Interactive comment on "Geomorphometry of drainage basins: a global view from the Shuttle Radar Topography Mission" *by* P. L. Guth

Response to Evans comments:

Fig. 1. Revised Fig. 7

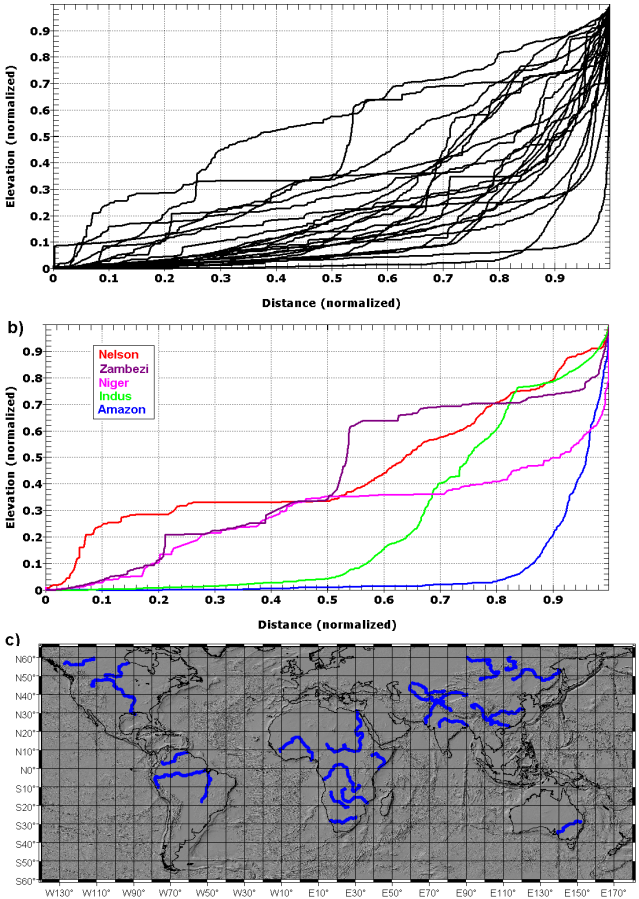
The comment about the figures is very well taken. As available in the PDF version on line, they are significantly degraded from the TIFF images submitted. I can submit them as larger versions if the reproduction can be improved. Specific changes I will

o Figure 7 has been redone with the noise in the elevations removed, and should be much clearer.
